**RE: Work Plan for Cargill Salt Alameda Facility, 2016 Clement Street, Alameda, California,  
SLIC Case No. RO0002480**

Re: Work Plan for Cargill Salt Alameda Facility, 2016 Clement Street, Alameda,  
California, SLIC Case No. RO0002480

## **Responses to Technical Comments and Proposed Scope for Additional Work**

Project No. CS1605  
 Cargill Salt Dispensing Systems Division  
 2016 Clement Avenue, Alameda, California  
**Figure 1. Proposed Soil Vapor Sampling Locations**

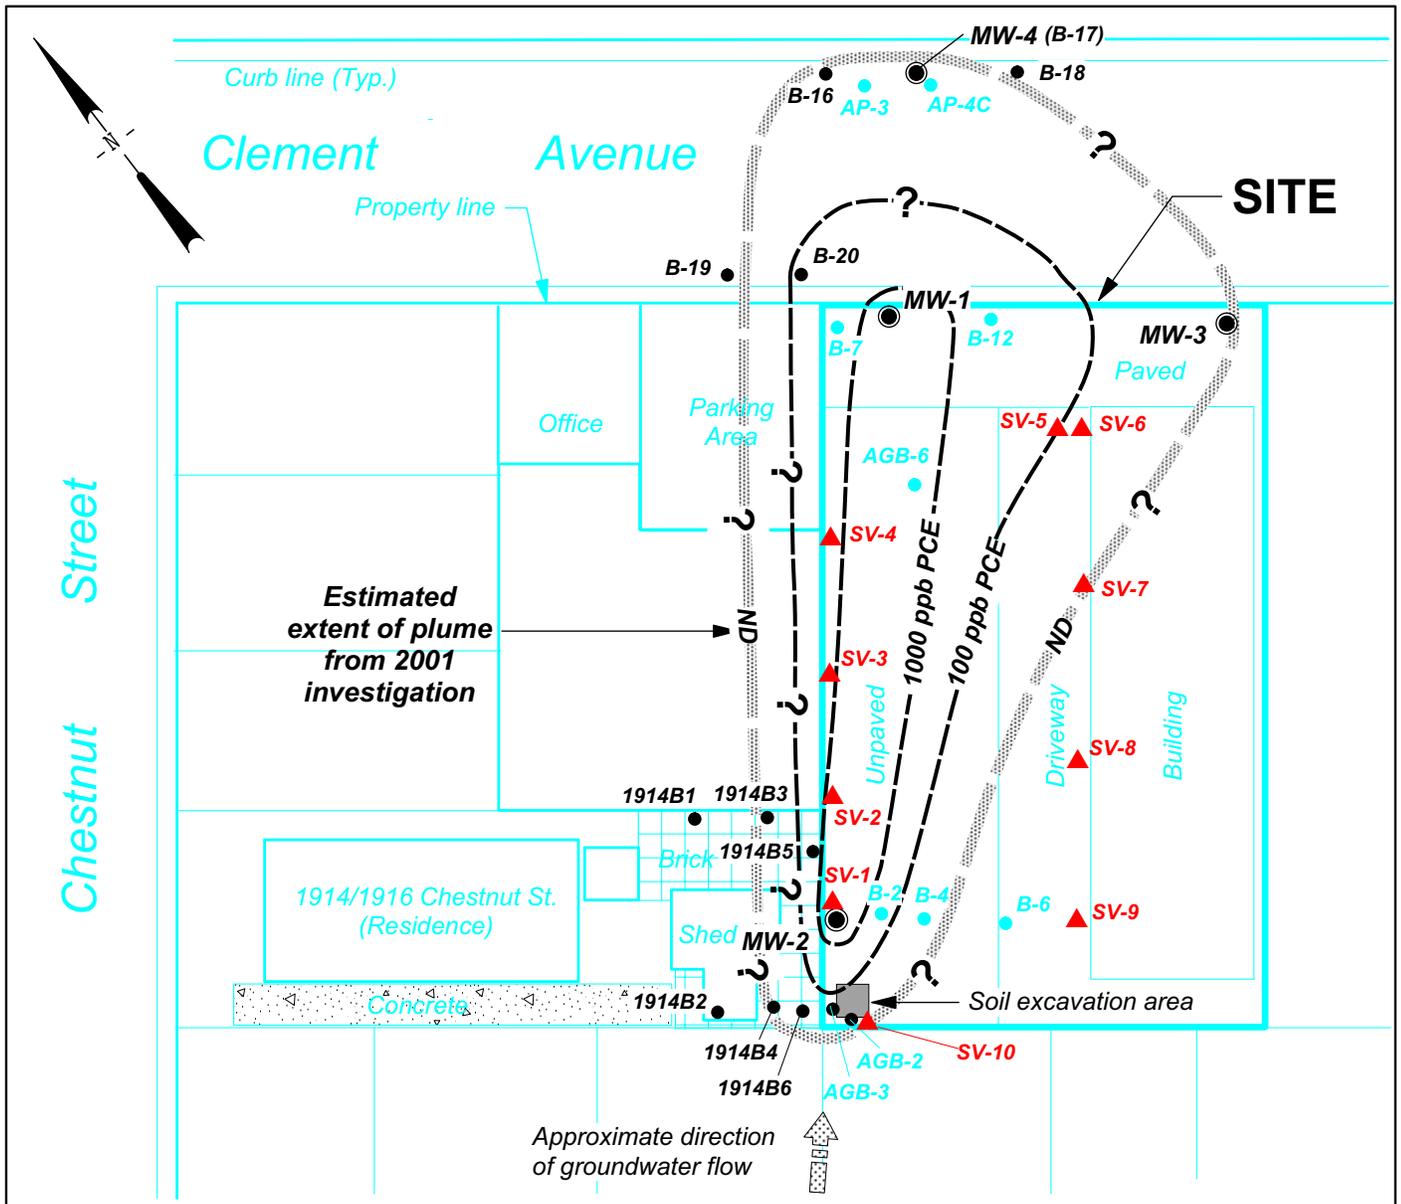
“In order to further evaluate the potential for indoor air intrusion, we request that you conduct soil vapor sampling. Please present plans for soil vapor sampling in the Work Plan...”

As discussed with you in our October 24, 2006 meeting, we propose to collect and analyze soil vapor samples at 10 on-site locations. The proposed locations are shown on Figure 1. Soil vapor will be collected at 5 locations underneath the asphalt driveway adjacent to the facility building and at 5 locations along the northwestern perimeter of the site. The proposed locations were selected to provide soil vapor samples adjacent to or near on-site and off-site buildings.

DTSC generally recommends collection of soil gas samples at depths of 5 feet and greater. As the depth to groundwater at the site is usually 5 feet or less (the depth to groundwater has fluctuated from approximately 2 to 5 feet over the last few years), it will not be possible to follow this guideline. However, we will follow the DTSC guidance for sites where the depth to groundwater is less than 5 feet and will collect 5 soil vapor samples beneath a paved surface (the asphalt driveway adjacent to the facility building) to evaluate the potential for vapor accumulation:

The depth for collection of the soil vapor samples will be determined on the day of the field work. The depth to groundwater will be checked in the on-site groundwater monitoring wells. To avoid sampling within the capillary fringe, the depth for the soil vapor collection will be one foot shallower than the depth of groundwater.

The potential for significant lateral migration of soil vapor in the vadose zone at the site appears limited as the vadose zone is very thin. However, the results of the on-site sample locations will be assessed to determine if conducting off-site soil vapor sampling appears warranted and recommendations will be presented in a report of results.
